ISSUE: Permit to Demolish/Capsulate (partial) and Certificate of Appropriateness for alterations

LOCATION: Parker Gray District
426 Earl Street

BAR#2024-00119 & BAR#2024-00151
426 Earl Street

Note: Staff coupled the application for a Permit to Demolish (BAR #2024-00151) and Certificate of Appropriateness (BAR #2024-00119) for clarity and brevity. The Permit to Demolish requires a roll call vote.

Figure 2: Proposed front elevation including new porch

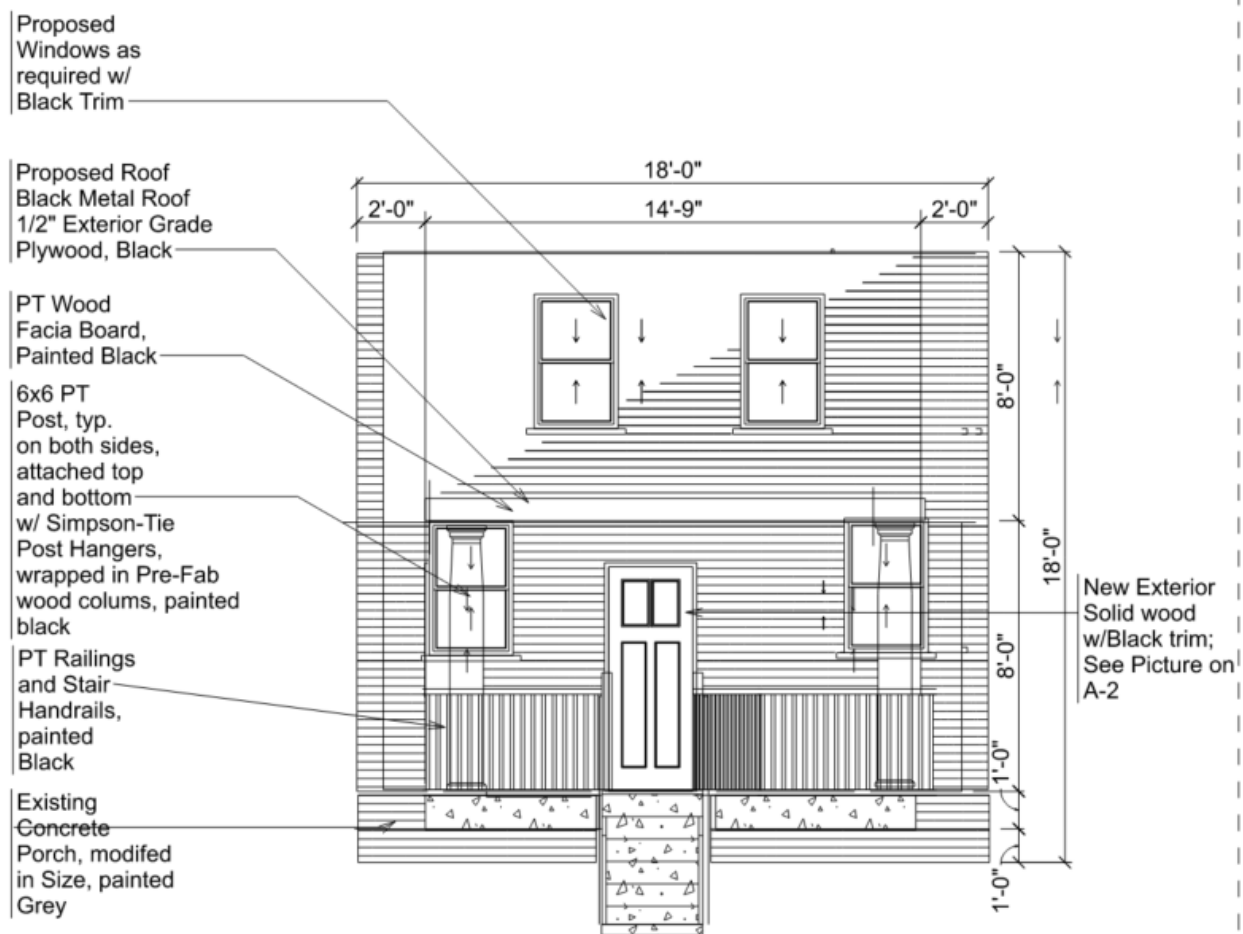
At the front of the building, the applicant is proposing to expand the existing entry stoop into a 14'-9" wide covered porch centered on the elevation. The porch will have a painted concrete base with decorative wood columns and a sloped standing seam metal roof. Pressure treated wood railings will be painted black to match the proposed black columns and roof. The existing front door will be replaced with a new door featuring a large glazed area with decorative metal and a raised panel. Note that the front door shown on the elevation is not the design for the proposed front door. The submitted drawings do not include a high level of detail regarding the construction and detailing for the porch (Figure 2).

While staff supports the introduction of a porch to this structure, the submitted drawings do not include a great deal of detail regarding its construction or configuration. As submitted, it is unclear how the roof structure will attach to the building and how this relates to the upper level windows. It is also unclear how the roof structure and the supporting columns will work with the trim and the drainage elements. The proposed columns are very formal in design and appear to be out of scale for the porch. Staff recommends that the applicant work with staff on the detailing of the porch columns and roof to make them compatible with the existing structure. The base of the porch is also somewhat unclear. The elevation shows the railings extending past the base of the porch and aligning with the first floor window and no detail is provided for the area under the painted concrete. Staff recommends that the applicant work with staff on this configuration to allow the porch to align with the windows and for the area under the concrete to be brick to match the building masonry.

1. The applicant work with staff on the final design for the details at the front porch including the columns, roof, and drainage elements.
2. The applicant work with staff to select a front entry door that is appropriate for the style of the house.

3. The edge of the front porch aligns with the edge of the first floor windows.
4. The area under the porch be enclosed with brick to match the brick on the house, similar to the existing entry stoop.

Figure 4: Proposed rear elevation

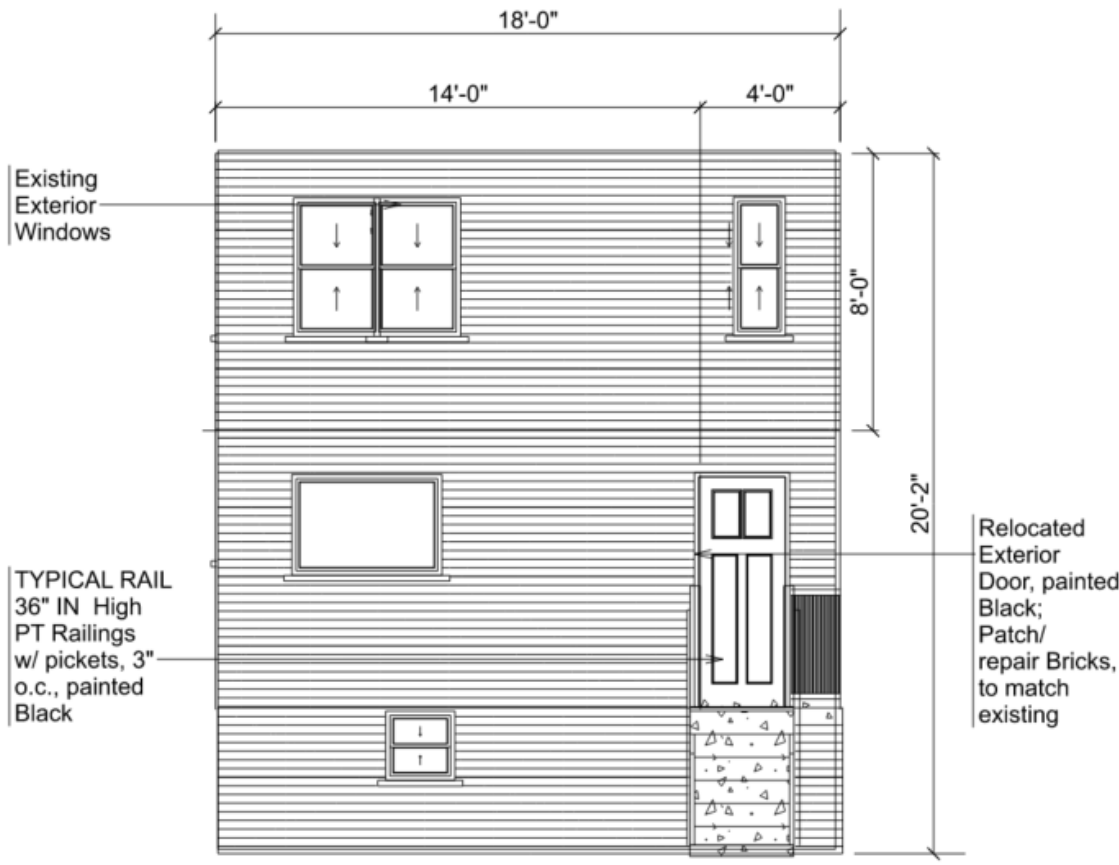
At the rear of the building, the applicant is proposing to modify the size of the ground floor window and install a single panel picture window in place of the previous window. The applicant is also proposing to relocate the door and build a new concrete entry stair and landing with wood railings similar to the front entry (Figure 4).

The proposed modifications to the rear of the building are more utilitarian in nature and do not represent significant changes to the design. Staff supports the modification of the ground floor window but finds that it should be aligned with the window above and that the configuration of the window should be similar to the configuration of other windows on the building. Similar to the front porch, the submitted materials are unclear on the design and configuration of the rear entry. The plan shows a narrow stair and similar landing that is aligned with the entry door where the elevation shows a landing that is larger, extending to the corner of the building. Staff recommends that the applicant work with staff on the design of the rear entry to develop a proposal that is compatible with the overall composition. The submitted materials are also unclear regarding the design for the rear entry door. The elevation shows it to be a design similar to the front door but as previously noted, the door being proposed for that location is different than what is shown in the elevation. Staff recommends that the applicant work with staff to select a door design that is appropriate for this secondary elevation. As with the side elevation, there are areas of brick that have been infilled and areas of brick that will need to be infilled on the rear elevation. Staff recommends that the applicant work with staff to ensure that this brick infill matches the adjacent wall.

6. The applicant work with staff to select a design for the rear door that is appropriate for the style of the house.
7. The first floor fixed window on the west elevation align with the window above and include muntins in a configuration similar to other windows on the building.

8. The stairs and landing at the rear entrance door are constructed per the plan.
9. All new windows and doors match those administratively approved under BAR2023-00434.

Second Floor Plans
SCALE: 3/8" = 1'-0"

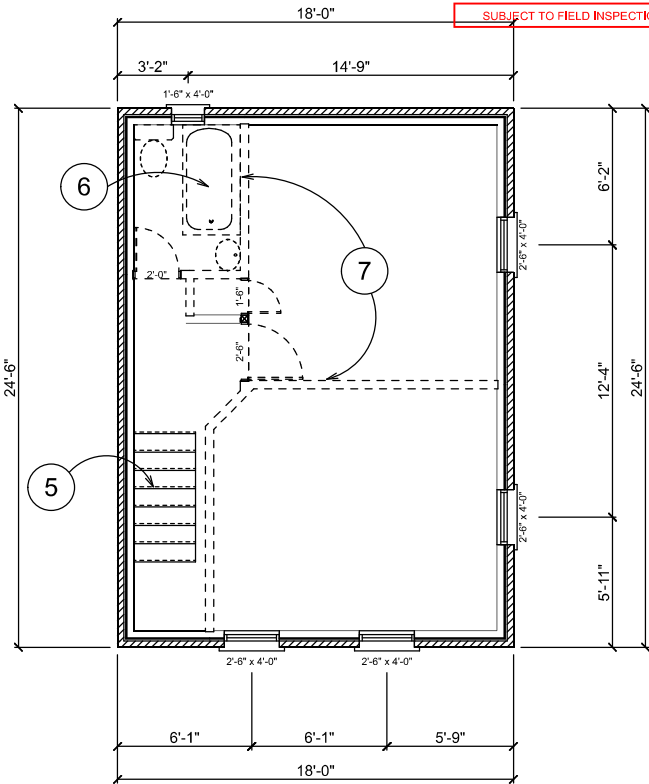
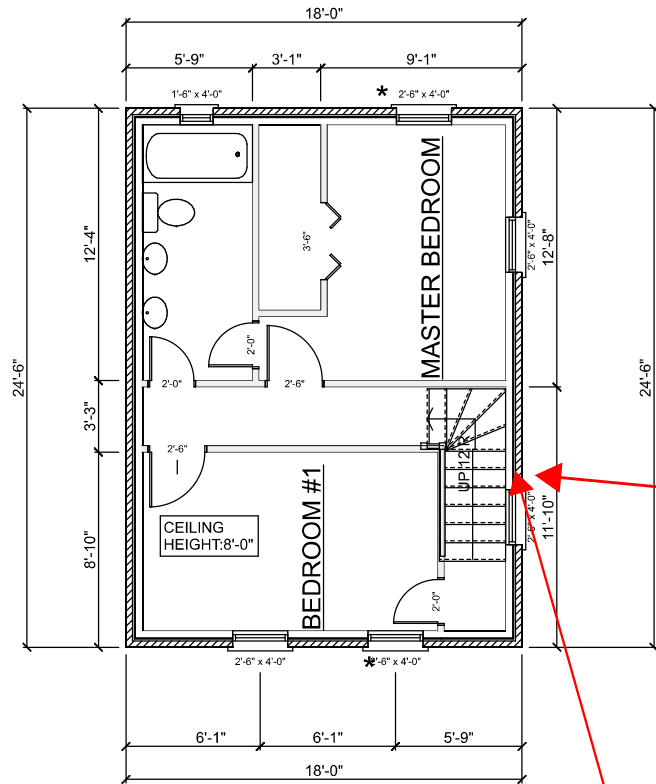
ADVISED APPLICANT, THEY WILL NEED TO SHOW STAIR DETAILS FOR WINDER STAIRS AND MUST COMPLY WITH vrc2018 311.7.5.2.1 APPLICANT WILL HAVE INFORMATION AT INSPECTION, REQUEST TO VERIFY IN FIELD ON INSPECTION 11.29.23
